# Statement of Revisions and Environmental Effects

## ALTERATIONS AND ADDITIONS 41 BAKERS ROAD, CHURCH POINT

Prepared by  
Beecraft P/L  
6A Larool Road  
Terrey Hills NSW 2084  
Ph. 94501530

December 2022

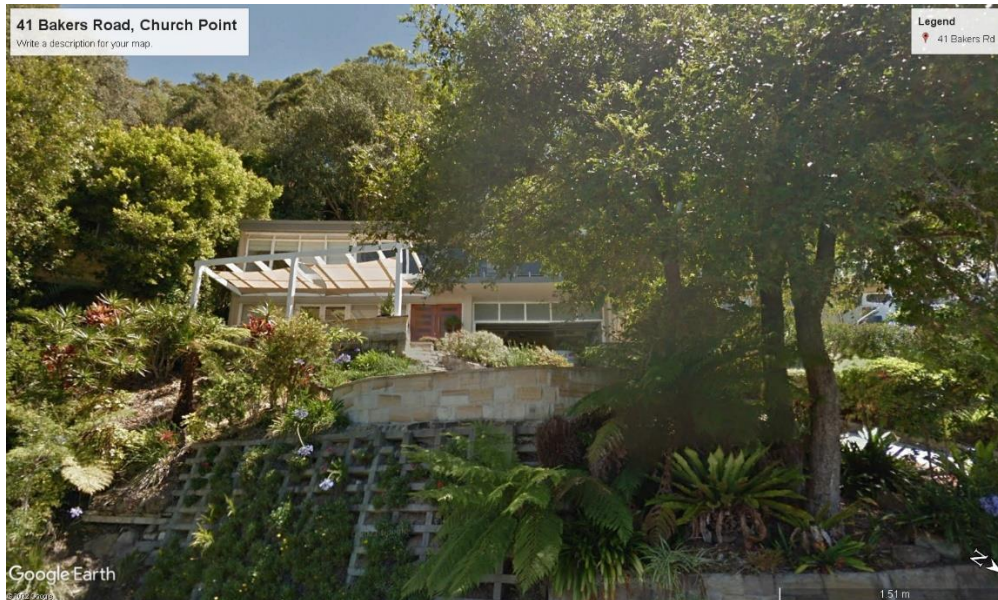
- *Vehicle manoeuvring in a forward direction is facilitated.*

**Comment:** There will be no change to the existing vehicular access within the property.
